**ALLEN & MAJOR
ASSOCIATES, INC.**

DRAINAGE REPORT

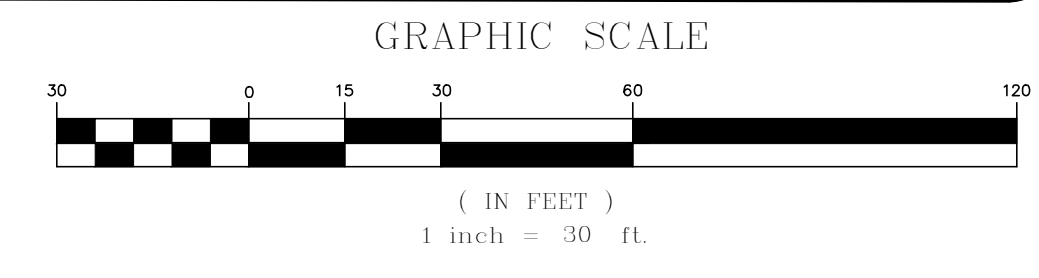
ISSUED FOR APPROVAL: OCTOBER 5, 2023
REVISED PER TOWN COMMENTS: FEBRUARY 29, 2024
REVISED PER TOWN COMMENTS: MARCH 25, 2024

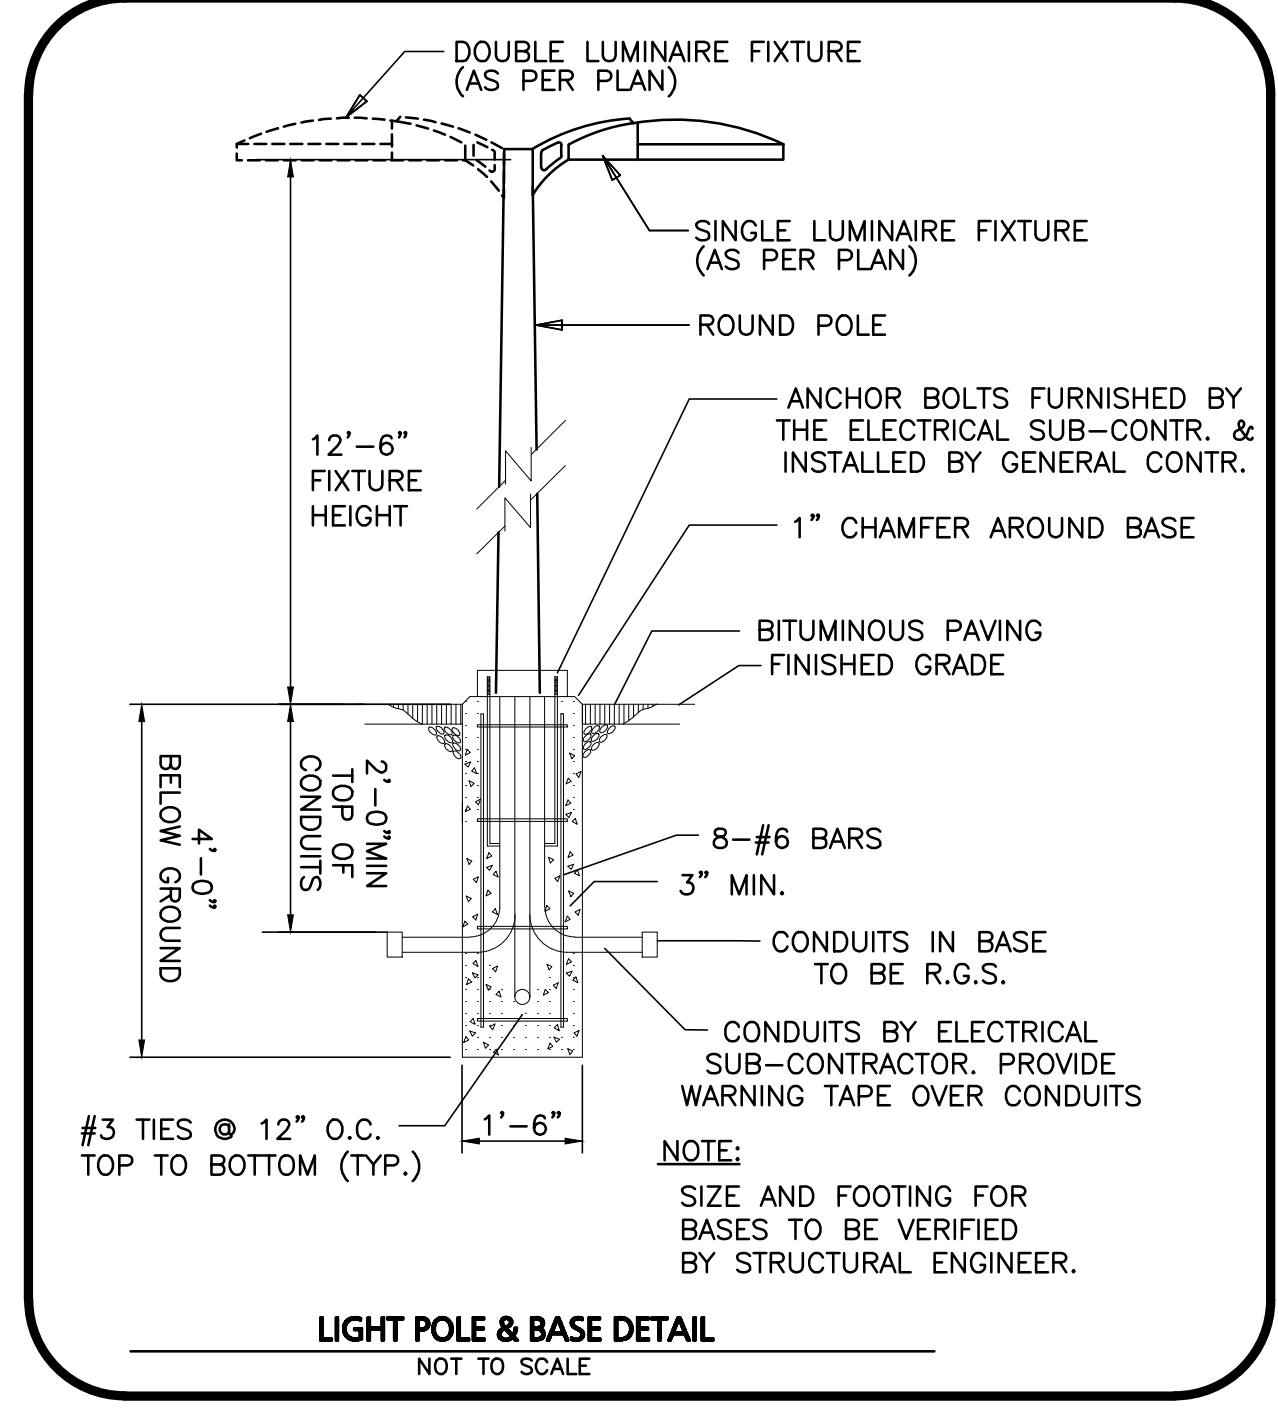
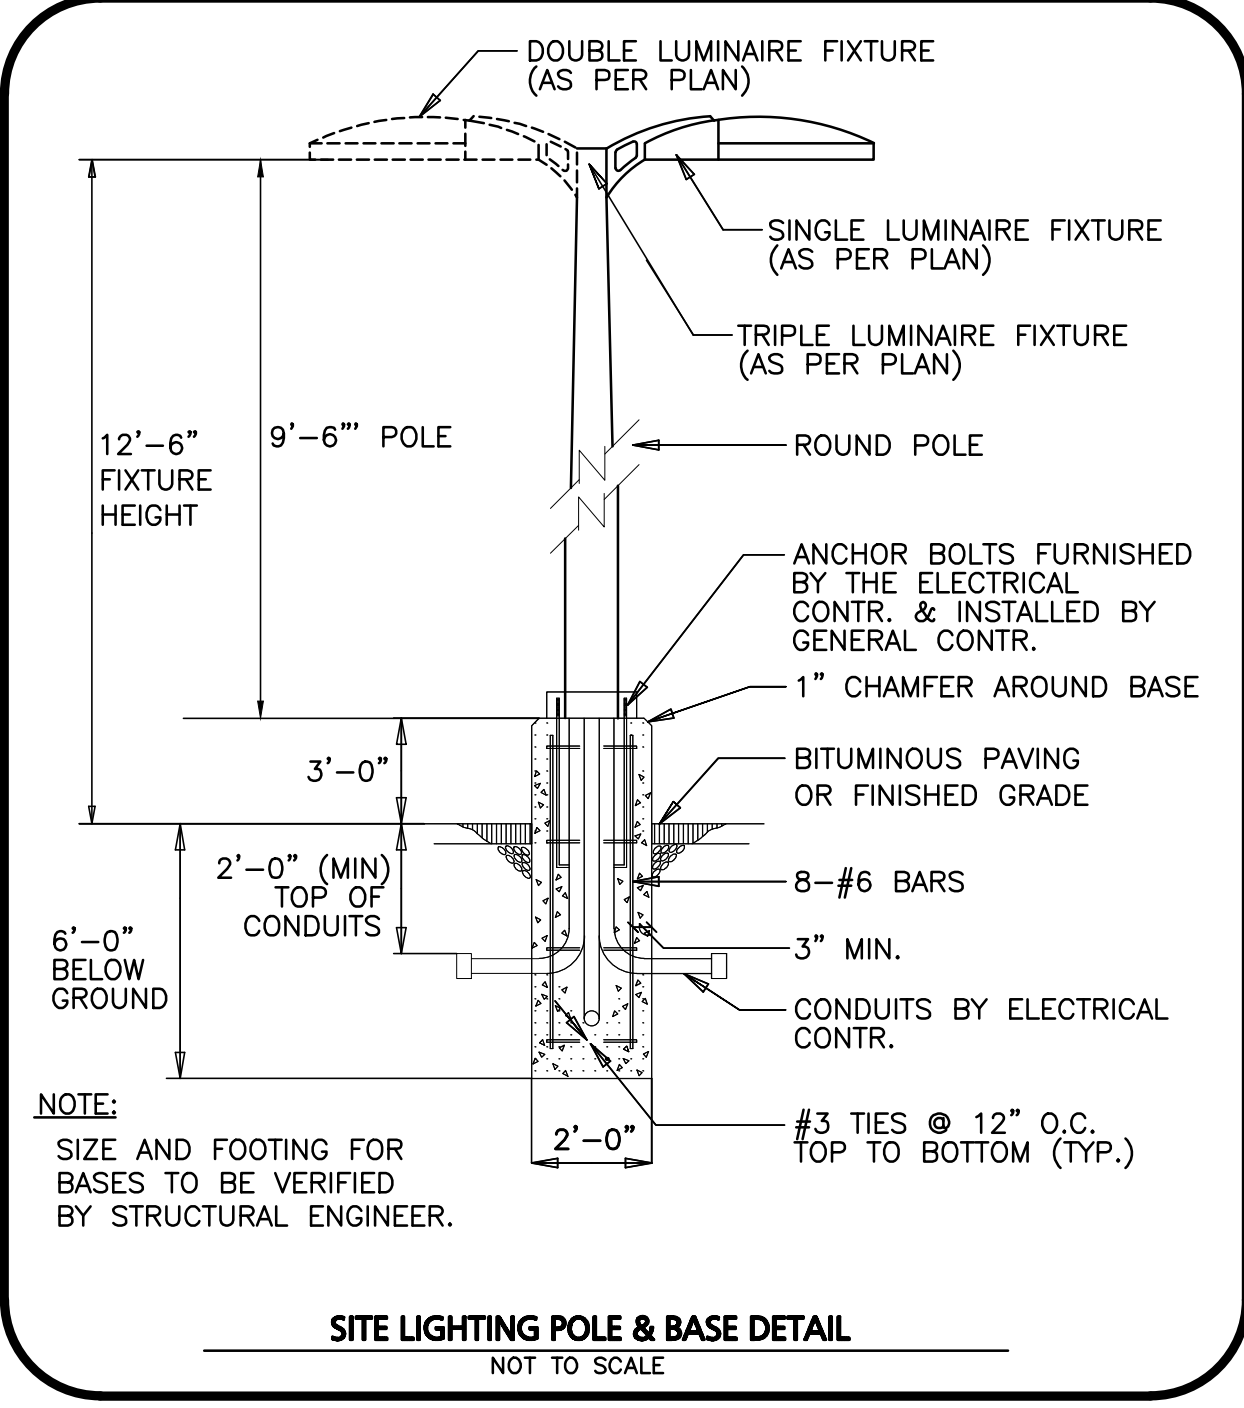
REV	DATE	DESCRIPTION
B	3/25/2024	REVISED PER TOWN COMMENTS
A	2/29/2024	REVISED PER TOWN COMMENTS

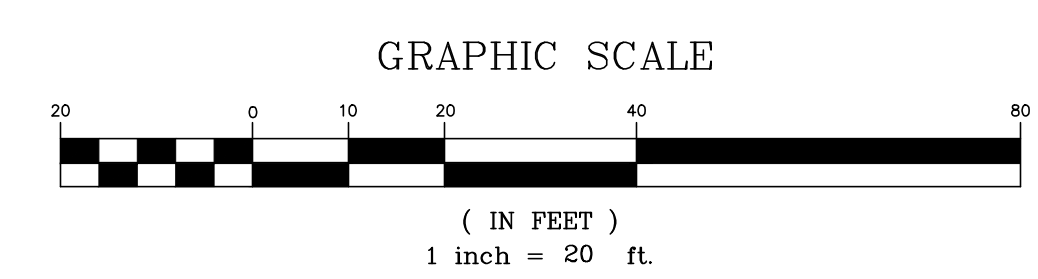
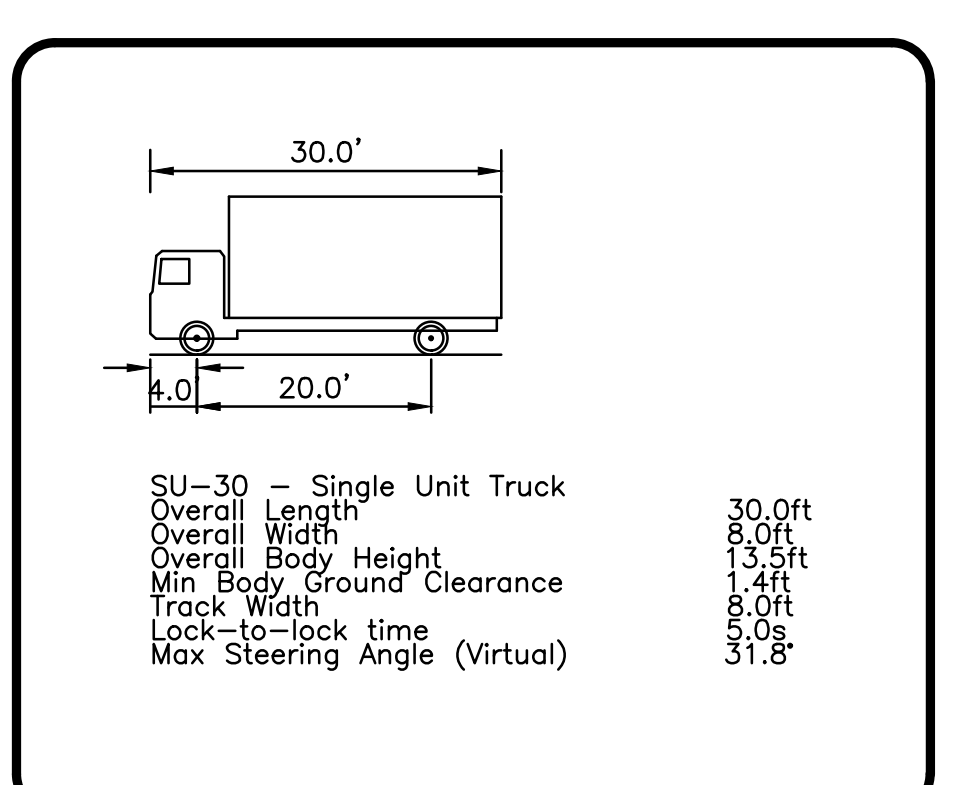
REV	DATE	DESCRIPTION
B	3/25/2024	REVISED PER TOWN COMMENTS
A	2/29/2024	REVISED PER TOWN COMMENTS

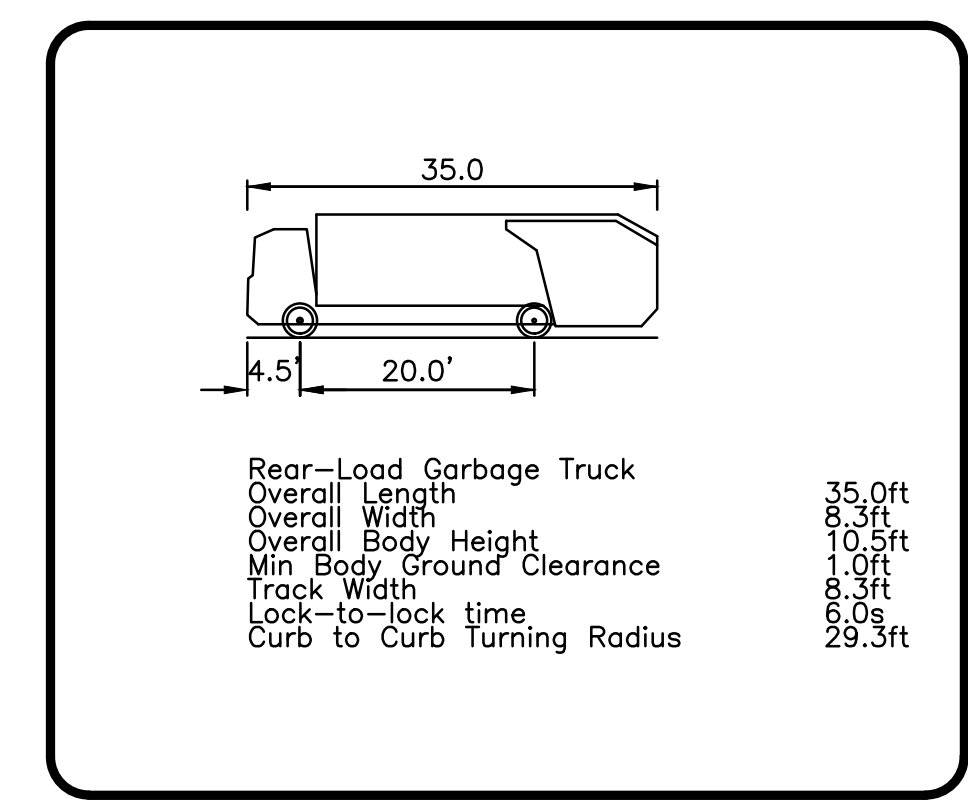
REV	DATE	DESCRIPTION
B	3/25/2024	REVISED PER TOWN COMMENTS
A	2/29/2024	REVISED PER TOWN COMMENTS

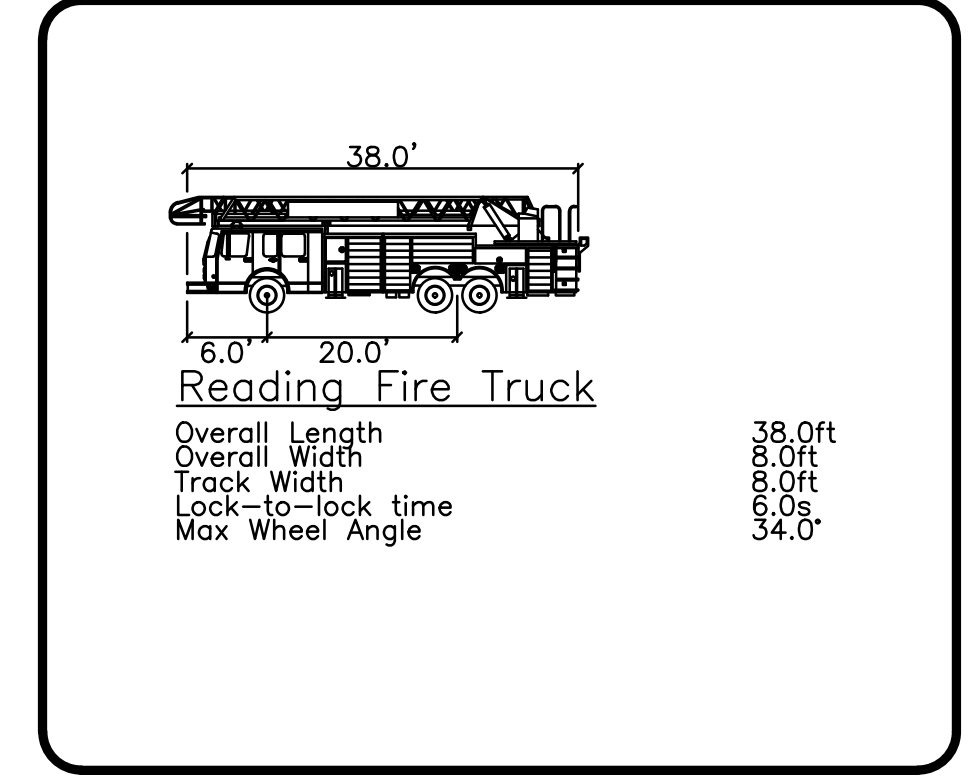
REV	DATE	DESCRIPTION
B	3/25/2024	REVISED PER TOWN COMMENTS
A	2/29/2024	REVISED PER TOWN COMMENTS

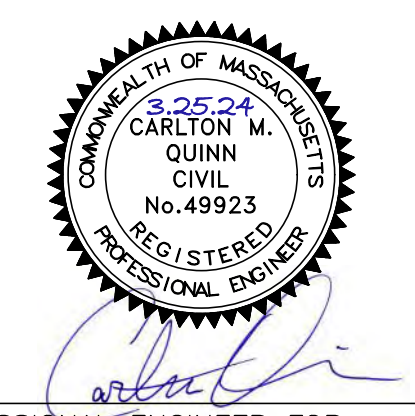
REV	DATE	DESCRIPTION
B	3/25/2024	REVISED PER TOWN COMMENTS
A	2/29/2024	REVISED PER TOWN COMMENTS

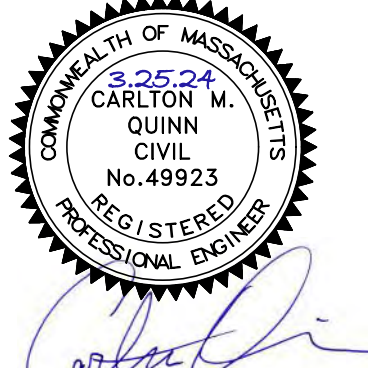
REV	DATE	DESCRIPTION
B	3/25/2024	REVISED PER TOWN COMMENTS
A	2/29/2024	REVISED PER TOWN COMMENTS
